**COMMISSION OF ARCHITECTURAL REVIEW
STAFF REPORT
April 25, 2017, Meeting**

14. **COA-015024-2017** (D. Kleymen)

**2310-2310 ½ Venable Street
Union Hill Old and Historic District**

Construct a new duplex.

1905 Sanborn Map for the Subject Block

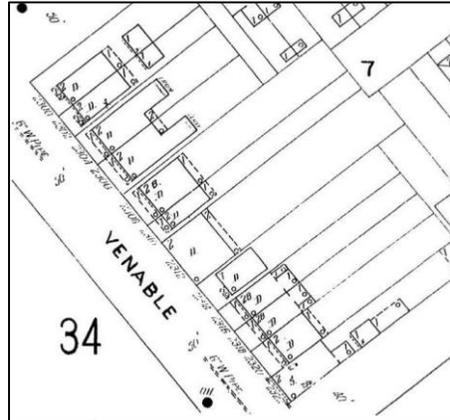
The applicant is proposing to align the structure with the property to the west. This setback is consisted with the setback pattern prevalent in the district.

The setback of the building to the west is consistent with the historical pattern for the block. The proposed structure matches this setback.
